## Proposal to introduce new criteria on the automatic levelling of headlamps based on the GTB glare and visibility studies.

This paper provides additional explanation supporting the joint GTB / OICA proposal, GRE/2015/05 and also updates some of the content of the proposed amendments to Regulation No.48.

### 1.5 The GTB proposal for a new Criterion to determine when automatic headlamp levelling shall be mandated

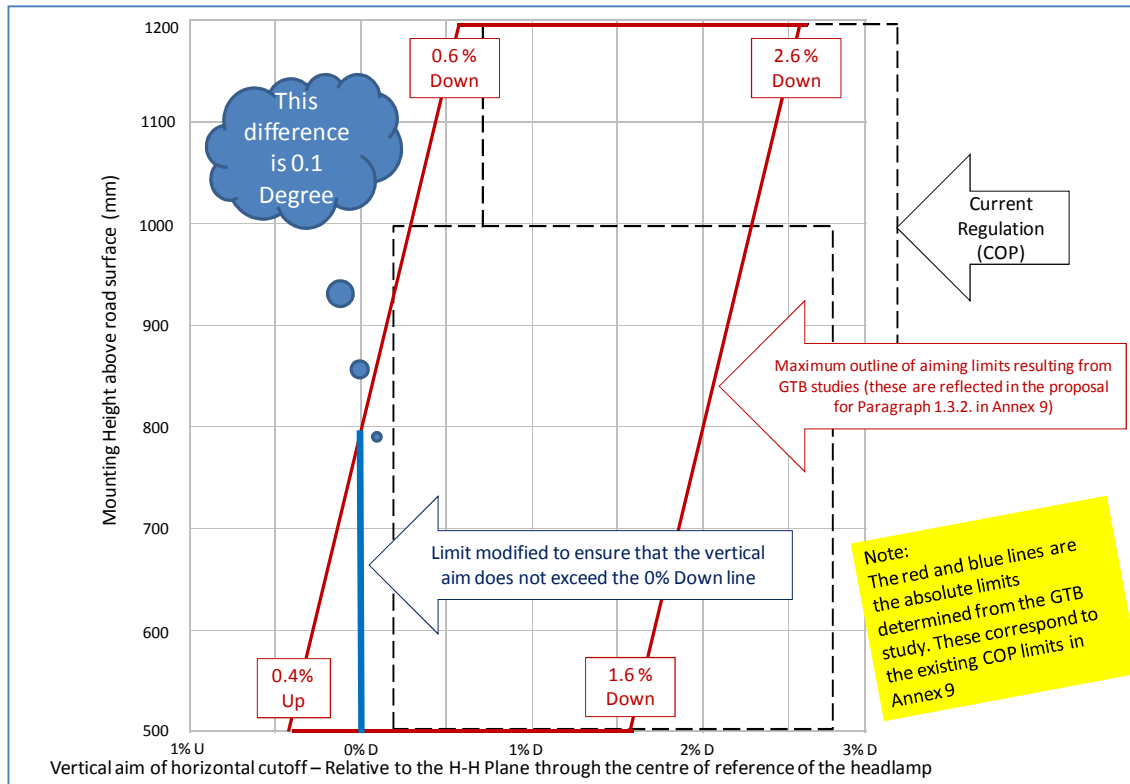
The paragraphs 13-17 of the justification of GRE/2015/05 provide a summary of the key points of the proposal to amend Regulation No.48. Figure 1 compares the proposed aiming limits with the current requirements of paragraph 6.2.6.1.2. However as the proposal relates to the absolute limits of aiming, for acceptable glare and visibility, these should be compared with the provisions in Annex 9, paragraph 1.3.2. The comparison then shows:

In summary, the joint GTB / OICA proposal introduces a criterion that is technology neutral and offers improvements in visibility range whilst retaining the existing control of the position of the cut-off in respect of glare. In the case that the vehicle characteristics, under the 50% loading condition, result in pitch angles that do not remain within the limits shown in the diagram shown above, there is a mandatory requirement to install automatic levelling. It is estimated that the proposed criterion will cover the loading conditions, under normal use, of around 90% of vehicles type approved to these new requirements. The remaining 10% of loading instances are corrected by means of the manual levelling system, or at the discretion of the manufacturer, by the installation of automatic systems. In the case of manual levelling, actions to improve driver awareness of its function will have to be considered to answer the concerns regarding misuse.
